INSPECTION REPORT  
Sedimentation Structure  
N12-M  
Kayenta Mine  
Navajo County, Arizona

for  
PEABODY COAL COMPANY

Dames & Moore  
10139-011-22

EXISTING  
MAXIMUM CROSS-SECTION  
A-A'  
N12-M

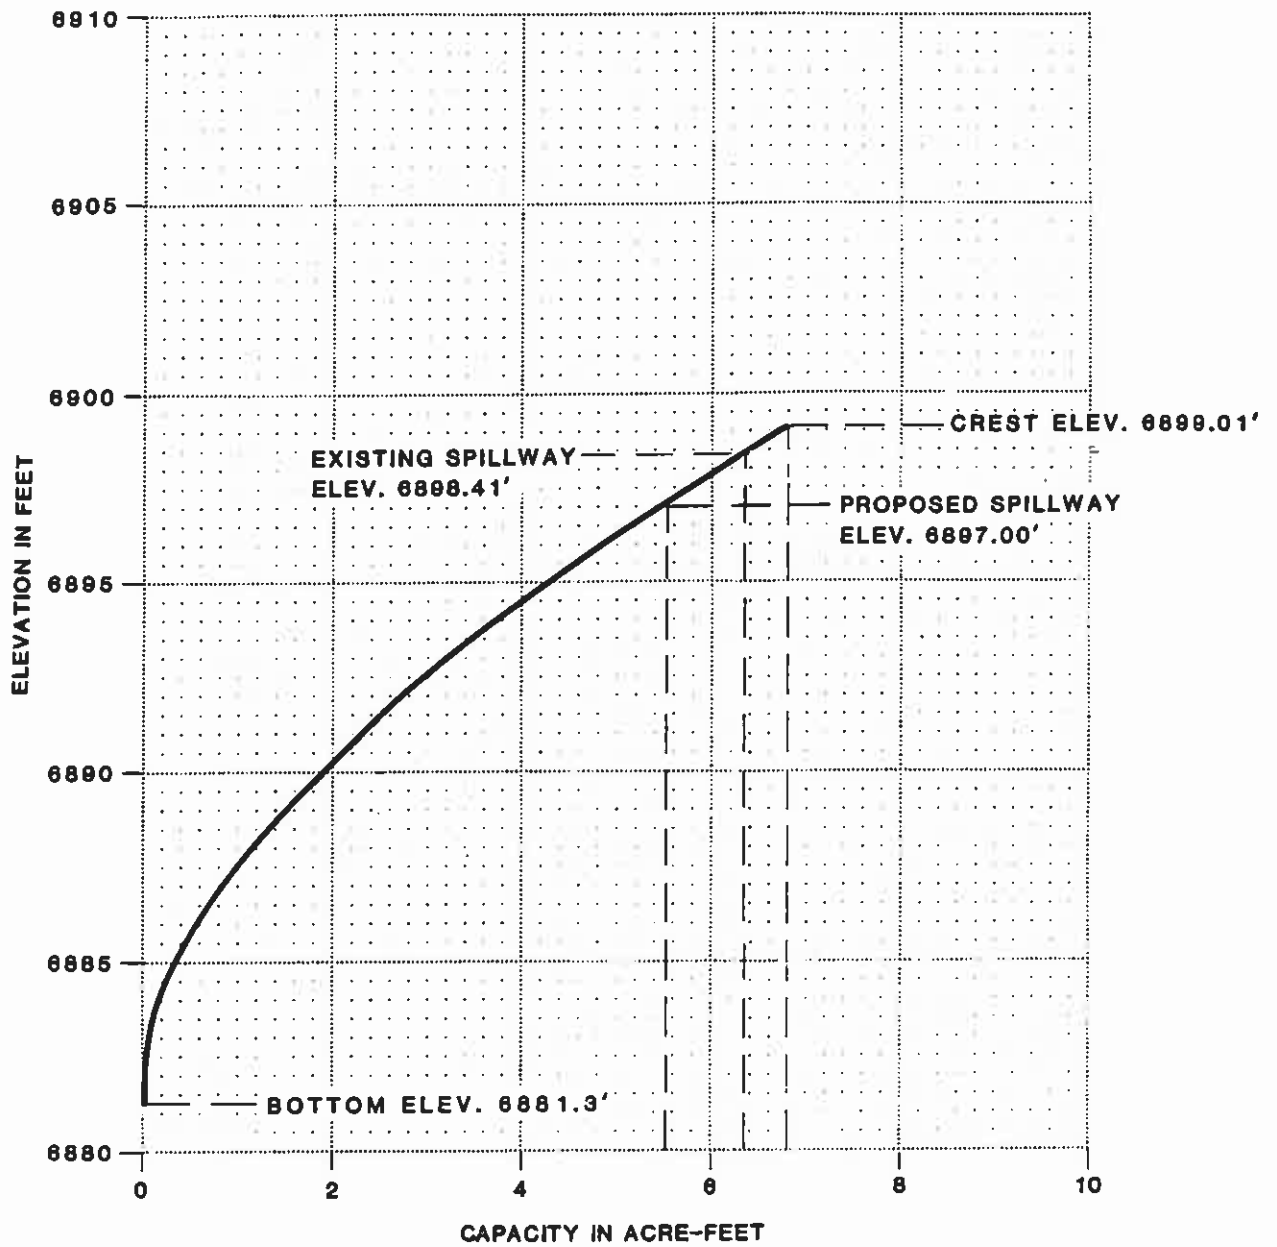
The N12-M embankment is lower in height; however, the downstream slope is steeper than the category standard; therefore, the embankment has factors of safety less than the design minimum.

The inspection of Structure N12-M indicated that the geotechnical problems consist of rill and gully erosion on the upstream and downstream slopes, the side slopes of the spillway channel; and an uneven embankment crest. Correction of erosion is considered a periodic maintenance task and does not require remedial action. The crest of the embankment should be

trimmed smooth and level to prevent masking of potential future problems. The downstream slope should be flattened to 4.0 horizontal to 1 vertical to meet stability requirements.

**SPILLWAY AND  
OUTFLOW CHANNEL  
CROSS SECTION  
N12-M**

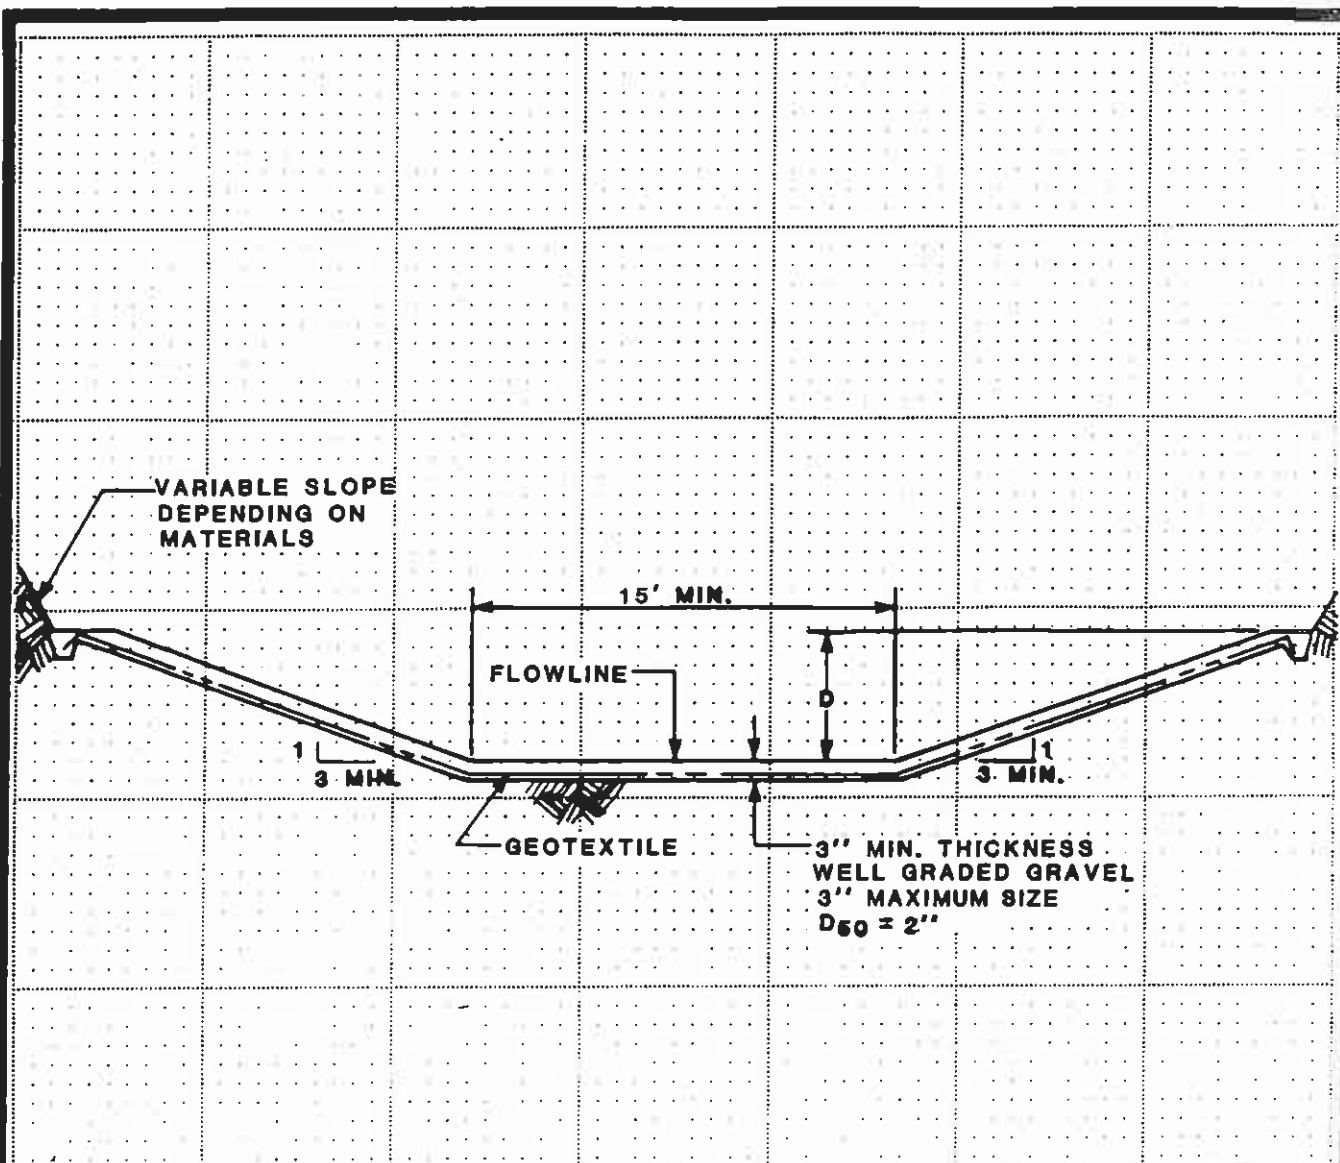
The storage capacity of Structure N12-M is adequate but the spillway capacity is inadequate. The structure does not have an outflow channel. The bottom elevation of the existing spillway channel should be lowered to elevation 6897.00 feet while maintaining the bottom width of 15 feet as shown on Plate 5. A trapezoidal outflow channel with the same bottom width as the spillway should be constructed along the alignment shown in Plate 1. The channel profile is shown in Plate 4 and required dimensions are shown in Plate 5. Both the spillway and outflow channel should be protected against erosion using geotextile and gravel as shown in Plate 5.

**SPILLWAY CHANNEL**

D = 1.5'

LENGTH = 30'

FLOWLINE ELEV. = 8897.00'

**OUTFLOW CHANNEL**

D = 1'
